Design Brief and Formal Submission to Urban Design Review Panel NOVEMBER 26 2020

PREPARED BY: MOMENTUM PLANNING AND COMMUNICATIONS AND FABIANI ARCHITECT

FOR: BAYVIEW HOSPITALITY GROUP.

PROPOSED DEVELOPMENT 6301 CAMPEAU DRIVE **KANATA ONTARIO**

CURRENT PROPOSED SITE PLAN

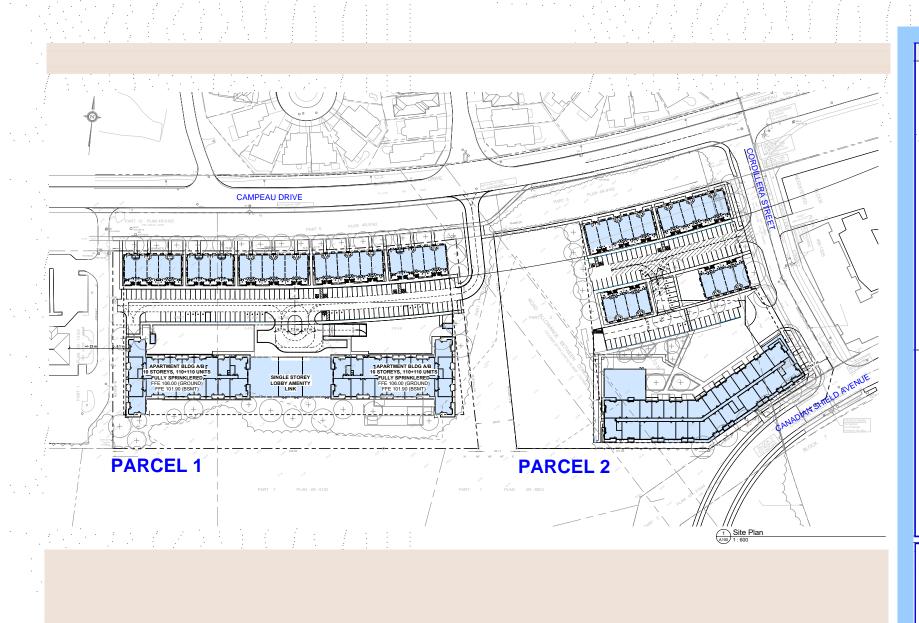
UDRP Comments – July 3, 2020

The Panel supports the proposed uses but there is an overall consensus that there is too much surface parking. The Panel is generally in favor of the proposed private street or laneway adjacent to the park but does not support perpendicular parking along that edge. The design should focus on the pedestrian experience moving though the landscape to establish a sense of place through. integration with the park.

- 1. This is a unique site and the proposed development would benefit from gradual setbacks, wider sidewalks, and tree plantings to
- knit it into the surrounding context. 2. The interface with the park would be improved

- by having a pedestrian connection on the park side of the property line.
- 3. The parkland is an asset to the site. Consider resculpting the 6th storey of the park facing buildings by increasing their height in some

- areas and lowering it in others. This would add variation to the continuous wall along the park and better relate the development to its surrounding context,

- 4. The Panel suggests studying some recent Scandinavian examples of courtyard design. Explore different built forms such as L-shaped buildings that provide courtyards, that would

- open out towards the park.
- 5. The Panel suggests reconsidering the access off Cordillera, to provide one entrance without
- exiting into the right of way. Rather than having 2 cross entrances, explore approaches to reduce

- some of the vehicular traffic.
- 6.At the corner of Campeau and Cordillera, the treatment of the units should not create an end
- wall condition on Cordillera, but perhaps a corner expression so that the building faces both

- Campeau and Cordillera.

Surface Parking 1. There is an extraordinary opportunity to weave the building, landscape and pedestrians use and circulation into the design of the site and to reduce the dominance of the car. 2. Studying the pedestrian experience of the site design will help to provide a community dimension to the development. 3. Parking should be reduced at the northwest. corner to provide a small plaza space with greenery between the townhouse units facing Campeau and the driveway to the west. 4. The applicant is encouraged to further examine the grade relationships and vehicular circulation to improve the relationship of the townhouses with the adjacent open space, ideally avoiding having them back onto parking lots. **Central Street** The central street needs further study and refinement, as designed it will be a very busy vehicular route and the pedestrian experience will need to be enhanced. A raised landscape or amenity area parallel to the street may help to further define it.

- The overall site layout has been revised to reduce the amount of surface parking and move it away from the park edge. As well, additional attention has been paid to integrating the apartment block designs to tie into and take advantage of the natural beauty of the park. Topographic challenges make it difficult to fully integrate the two parcels with formal pedestrian links however, leaving much of the site untouched will allow for informal access throughout the subject property.
- Additional meetings were held with Planning and Urban Design staff to refine the overall design prior to submission of the site plan control application.

- 1. The entire site layout has been revised with additional tree plantings. Special attention to Kanata's natural design ethic by retaining significant natural areas.

- 2. To avoid significant rock removal and damage to natural state, design has opted for informal pedestrian access across the property line.
- 3. All of the apartment blocks have been fully redesigned and with increased articulation at the ends. On Parcel 1 the building mass has

- been broken by a 1 storey lobby atrium. Additional height will provide for greater views
- into the park.
- 4. The apartment blocks have been redesigned to create a true base-middle-top profile. The block on Parcel 2 has been articulated to follow the

- corner and animate the street level with commercial space.
- 5. Parcel 2 has been redesigned to relocate all access to the Cordillera frontage. One access serves the townhouse surface parking and the

- 2nd provides access to the underground parking and a loading bay for mixed use apartment.
- 6. Special attention has been given to the eastern facades of these townhouse blocks to limit the exposure of blank walls.

- 1. Surface parking has been generally reduced and reorganized to create more landscaped space and encourage pedestrian movement.
- 2. Noted and addressed.
- 3. The stacked dwelling blocks have been shifted eastward to create more than a 5 metre side yard for this purpose.
- 4. The nature of back to back stacked dwelling design requires this proximity to the parking area. Technically, two sides of this housing form are 'front-facing' so there is no block that 'backs' onto the parking lot. However, to address panel concerns regarding the potential impacts of blank walls of a parking deck, the revised design has dropped the level of the parking for the apartments so it is fully underground allowing for seamless pedestrian movement.

The revised site layout removed the focus on the use of the road allowance between the two parcels. This area now only provides access to Parcel 1. The potential for connecting the parcels with a pedestrian path inside the site is still being explored but is challenged by significant grades.
